FISH DISTRIBUTION DATABASE CATALOG/ATLAS
CORRECTION FORM

MAP: COLB Bay A-1

WATERWAY NUMBER: 283-42-10600-2001-3025-4019

Subject: King Cove airport changes.

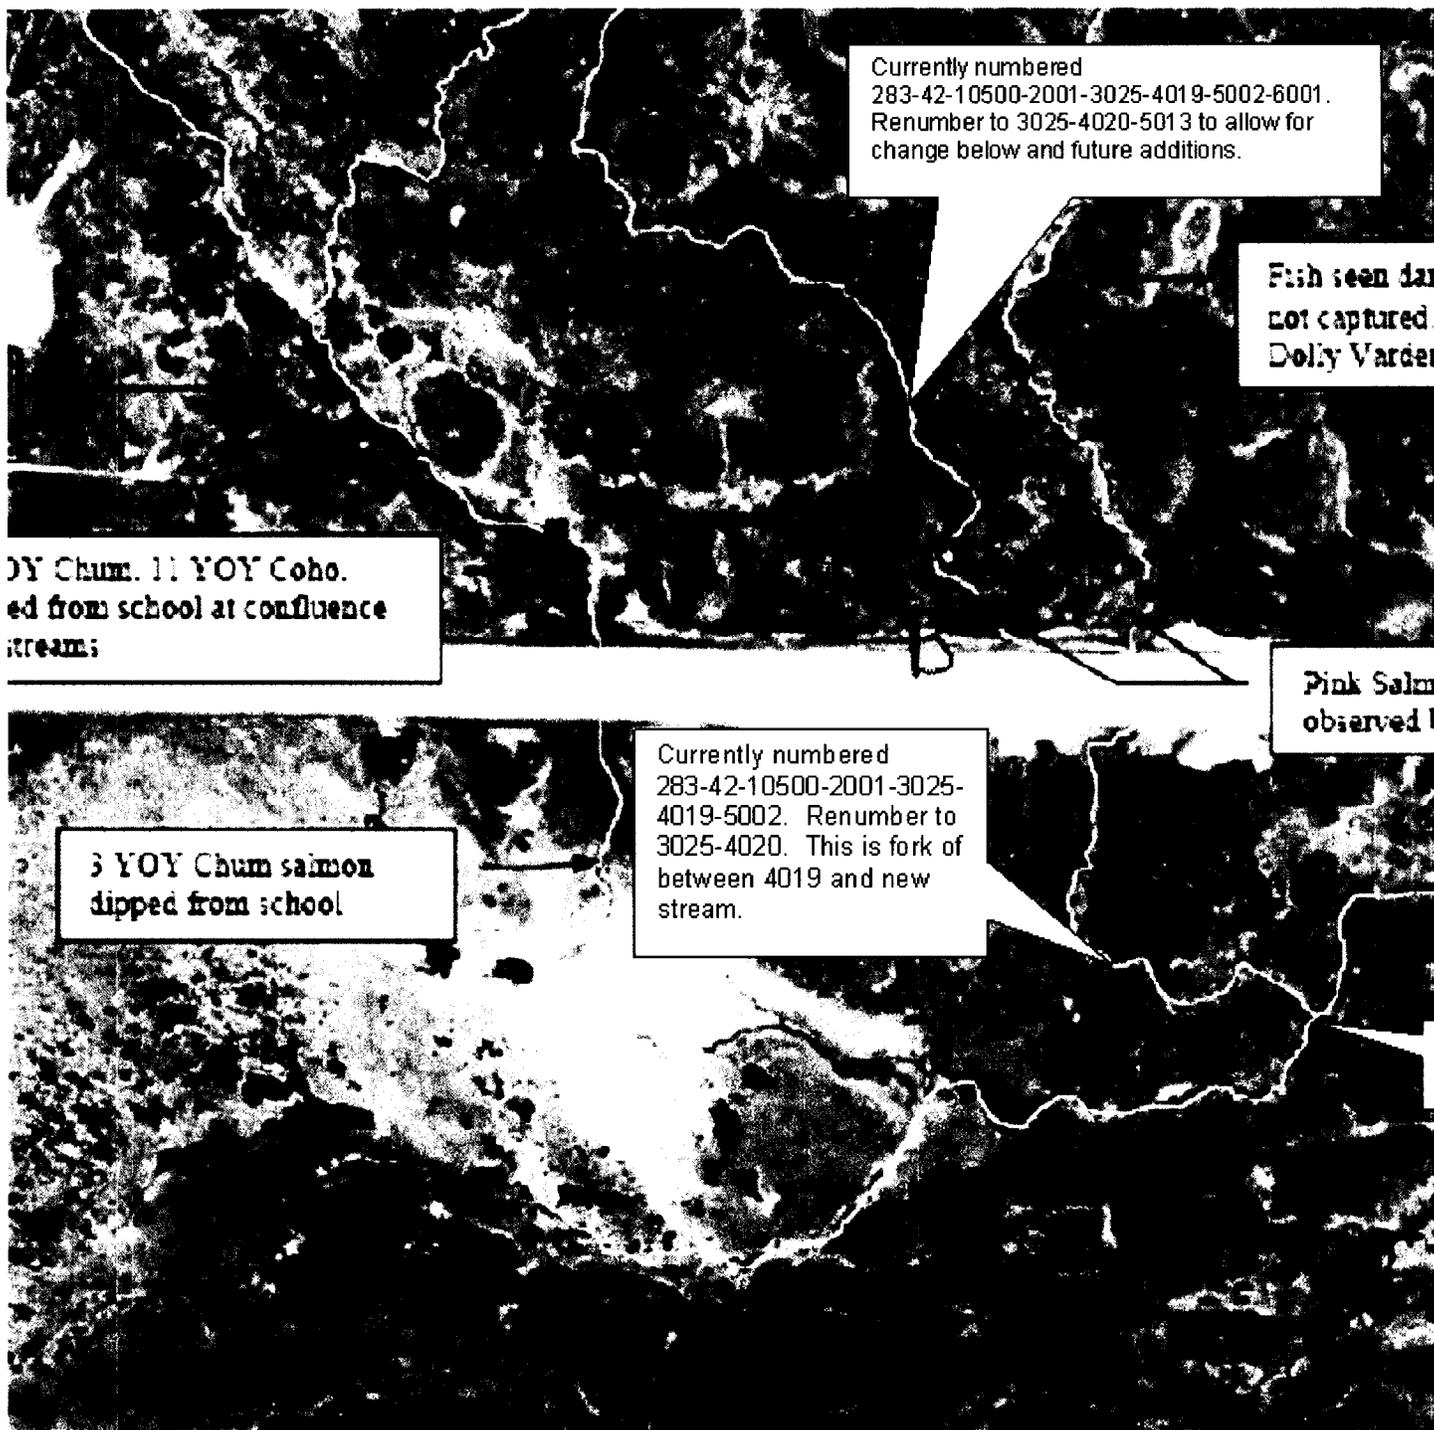
DESCRIBE CHANGE(S): Change 5001-6002
to 4020 - 5013 (trib of 3025 not
4019) NHD inconclusive

Here is photo with suggested renumbering. Let me know if it doesn't come through OK. I did it within Word right in the email. Basically, renumber 283-42-10500-2001-3025-4019-5002. Renumber to 283-42-10500-2001-3025-4020. And renumber 283-42-10500-2001-3025-4019-5002-6001 to 283-42-10500-2001-3025-4020-5013. Based on the flows in the streams at the runway and the photo I think the logical dividing point for streams 4019 & 4020 is their common fork.

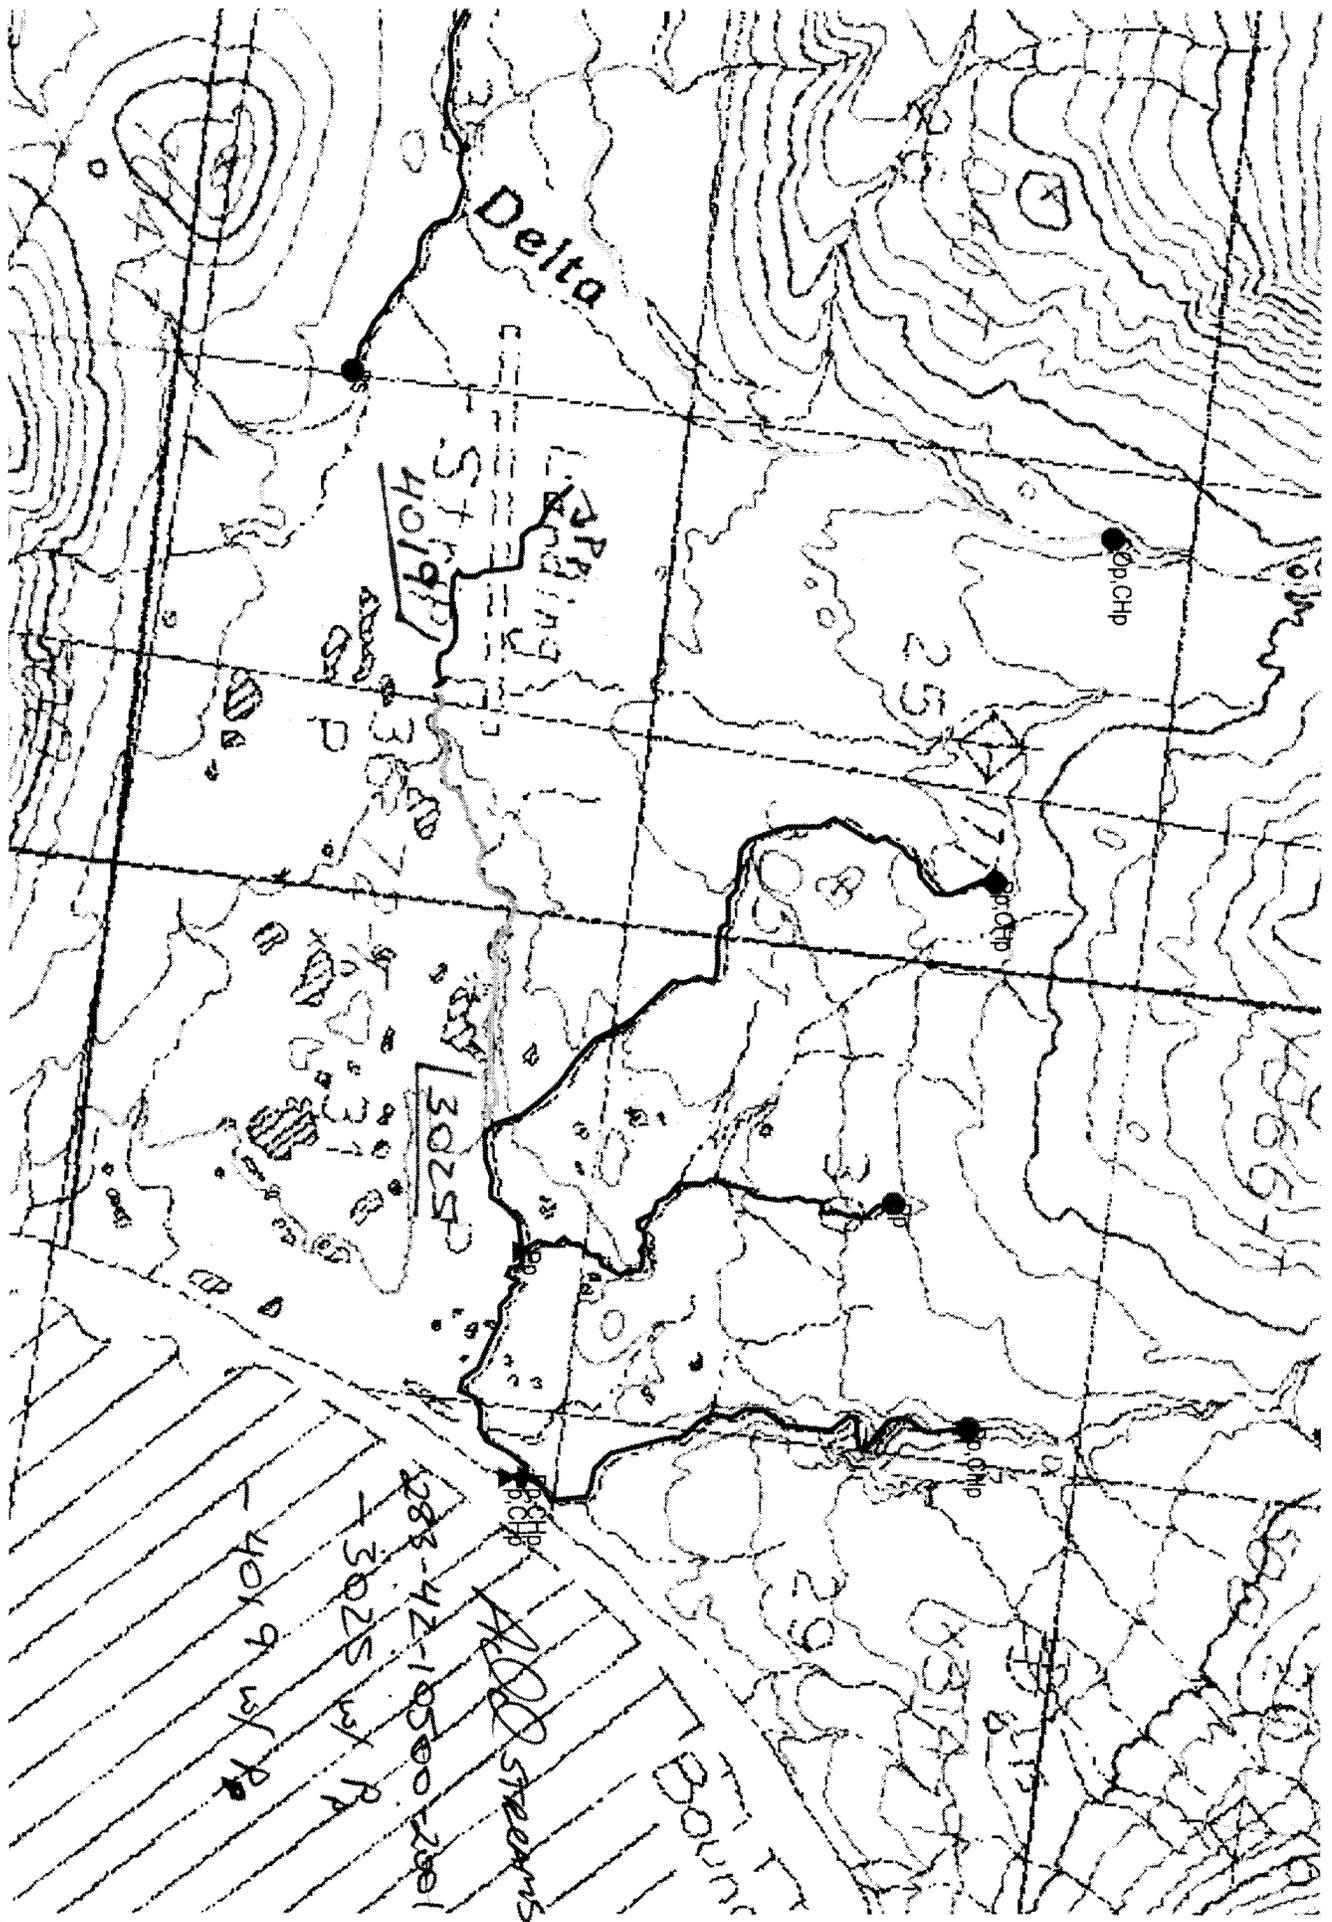
Comments: Add stream 283-42-10500-2001-3025-4019 with Pink presence per attached information.

Attached are stream surveys of 283-42-10500 dating back to 1992. We do not have a breakdown of how many fish were observed in each tributary. Each year however a considerable percent of the fish (pink salmon) were observed in 2001 up to about 1-200 yds from the end of the runway.
